NOTICE

- a. Discussion regarding concept plan for Transportation Oriented Development (TOD) located at approximately 500 West 750 North (Parcel No. 02-043-0044 and 02-043-0047)
- b. Consideration and approval of October 5, 2023

From: Bryce Wheelwright
Sent: Monday, October 16, 2023 8:10 AM
To: Michelle Drago
Subject: Fwd: Plans for Lakeside Village

Subject Plans for Lakeside Village

MINOR ARTERIAL - 66' R.O.W.

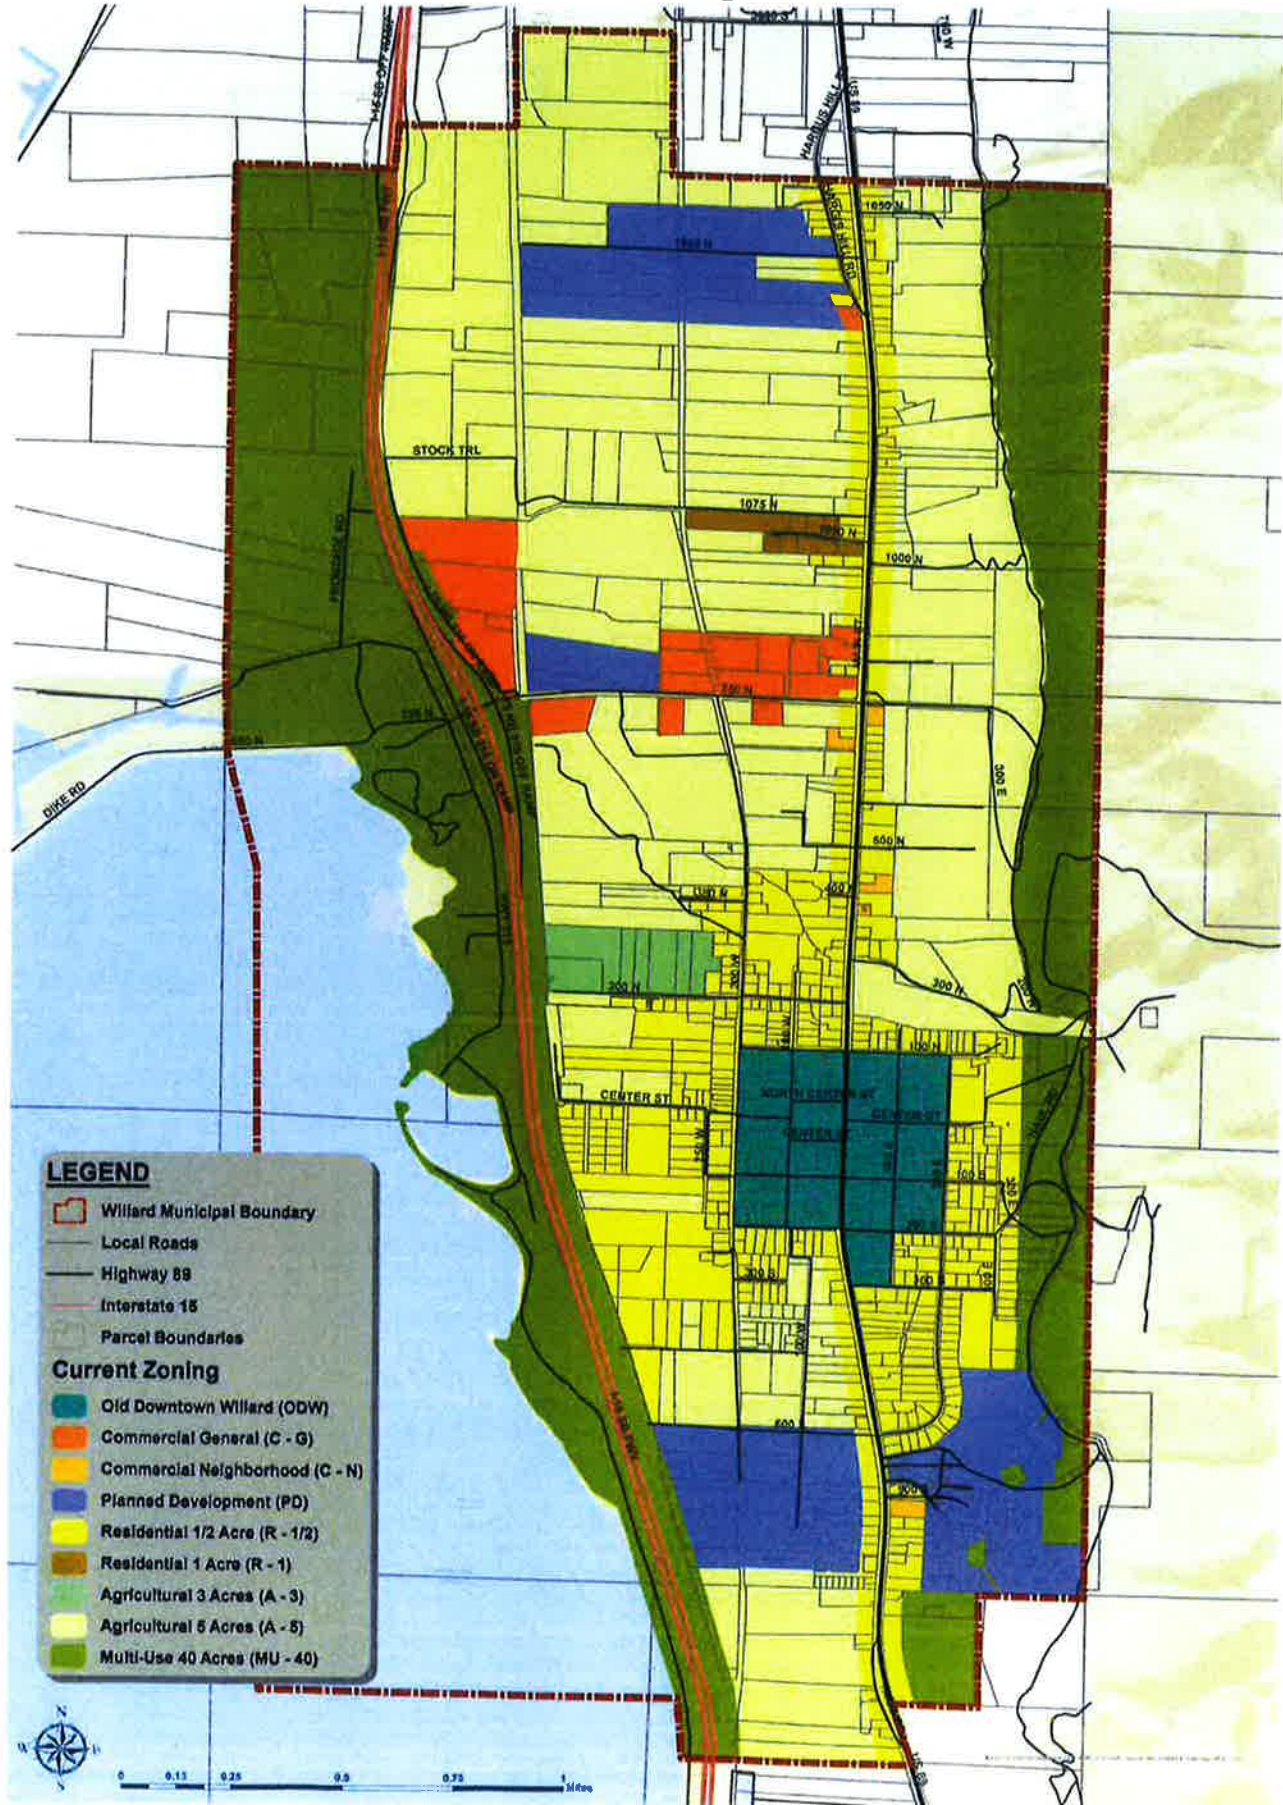
There are a couple of things I noticed. The 500 West roadway does not match the street section that I sent to you on Sept. 26th. The right-of-way will need to be 66' wide plus it will need to widen at the intersection to allow for all movements at the intersection. Also, the 300/400 West alignment appears to be sharing the ROW with the adjoining property. This works well if the neighboring property owner is willing to participate with the necessary ROW for the street, however, they already have frontage on 200 West so I'm not sure they will be willing. We do not allow for partial-width roadway construction. The entire width will need to be constructed.
